X3T9.2/89-158

COMMENT #2

Subject BSR X3.131-198x, Small Computer Systems Interface (SCSI-II)
TRANSMITTAL OF PUBLIC REVIEW COMMENT # 2

Photomatrix Aperture Card Scanner

Aperture Card Scanner Orientation:

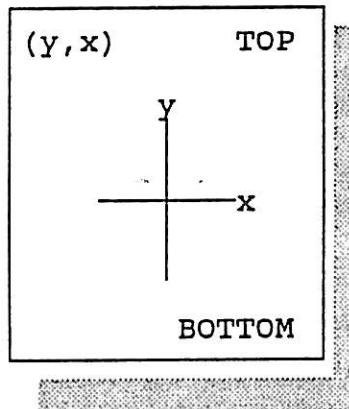
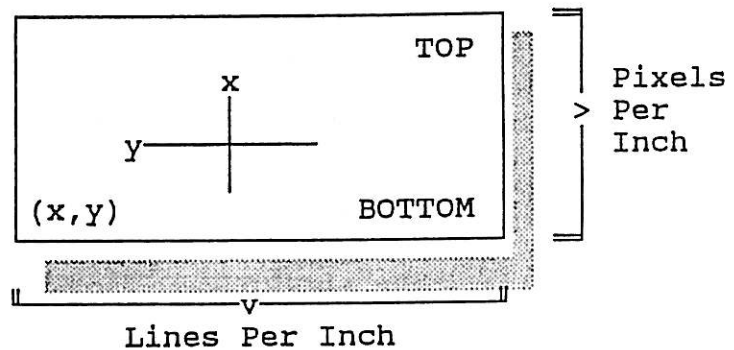
Without going into a great deal of detail in this letter, I have enclosed a copy of our SCSI-2 specification as implemented on an aperture card scanner. Please refer to that copy in regards to the commands that are listed next. The major differences come in the following commands (I have marked these in the enclosed document with tabs for easier reference): REQUEST SENSE (lack of appropriate error codes), GET DATA BUFFER STATUS (lack of Hollerith data available, and lack of an adequate communication scheme with the initiator when breaking up images generated that are larger than the scanner memory can hold [i.e., buffered transfers as defined do not adequately cover dynamic or "non-stop" scanning of an aperture card, which may produce up to 32 Megabytes worth of image data]), OBJECT POSITION (the object or media, in this case an aperture card, may be unloaded to 1, 2, or more "bins"; the "unload" position type of this command does not provide for this), and SET WINDOW (the X- and Y- axis orientation have been rotated on the aperture card scanner, as such what would be "Upper Left"

on a paper scanner is actually "Lower Left" and rotated on an aperture card scanner; other values in the Window Descriptor Block also differ slightly).

Due to the orientation of the media through the scanner, the "Upper Left X" and "Upper Left Y" values of the Window Descriptor block (see below) have been changed to "Lower Left X" and "Lower Left Y". PHASE ONE IMPLEMENTATION ONLY DOCUMENTS THIS DIVERGENCE FROM THE SCSI-2 SPECIFICATION. IN THE PHASE TWO IMPLEMENTATION, to distinguish this orientation from the standard format for this command, the user will set bit 6 of the Control Byte (indicating a vendor unique condition). If this is not done, the ACS will return a CHECK CONDITION. The data returned by a following Request Sense command would return ILLEGAL REQUEST in the Sense Key field and B0h ("Window Parameter Error") in the Additional Sense Code field.
